Project Name State and Water Mixed UseMaster File # 19-1844☒ Concept Design ReviewDate: Jul 25, 2019

CITY OF OLYMPIA
BASIC COMMERCIAL DESIGN CRITERIA
Chapter 18.110

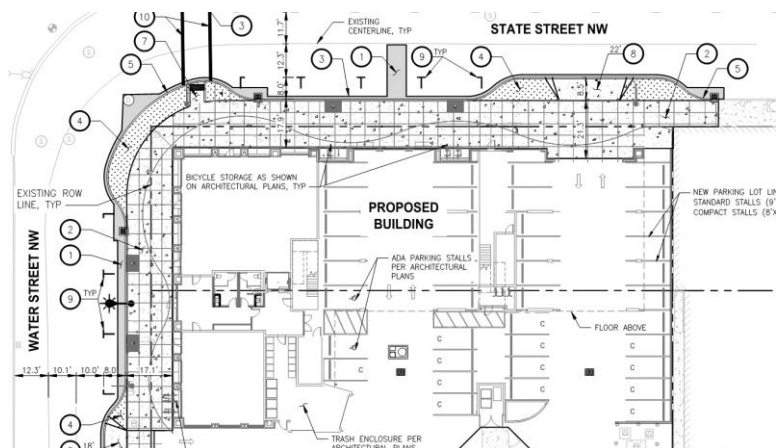
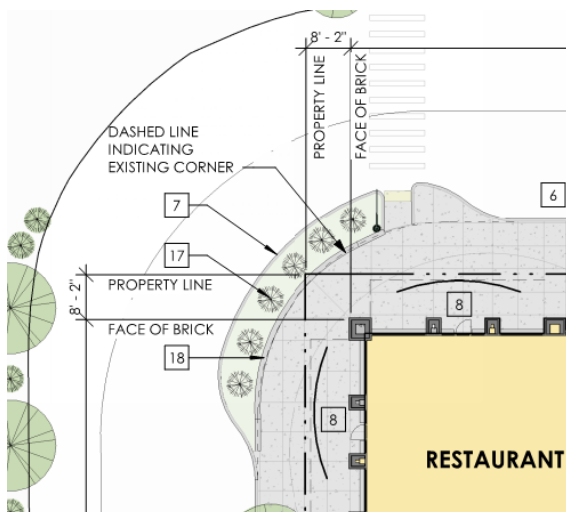
The design program includes a broad range of pedestrian amenities, including a curvilinear landscaped seating ledge/perch at the corner intersection, outdoor seating for the restaurant space, short-term bicycle parking, pedestrian benches, landscaping and artwork proposed on the blank wall sections on the north facade between the parking garage and the street. The civil plan set depicts a curvilinear design feature in the sidewalk that adds interest – however, this feature is not present in the architectural plan set.

- At the detail design stage of review, provide design options for the proposed mural or artwork installation along the north facade.
- Add the patterned sidewalk design to the architectural plan set and depict the design details at the next stage of review.

Figure 1: City of Olympia Official Zoning Map. Ord 4336. Revised 1985. Sheet 7.

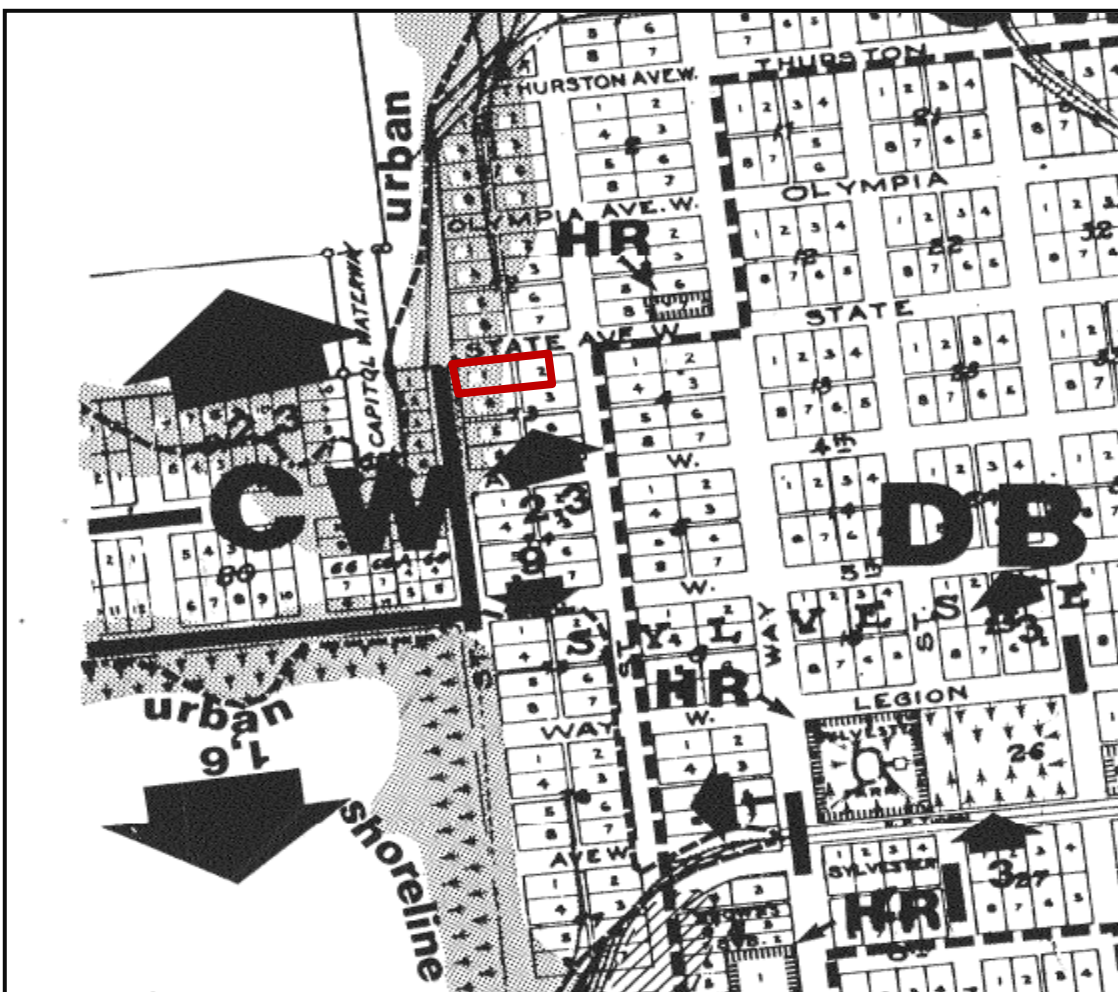
The project proponents submitted a view corridor analysis that demonstrates that views of Capitol Lake, Budd Inlet, the Olympia Mountains, and the Capitol Building will not be obstructed by the building (Attachment 7).
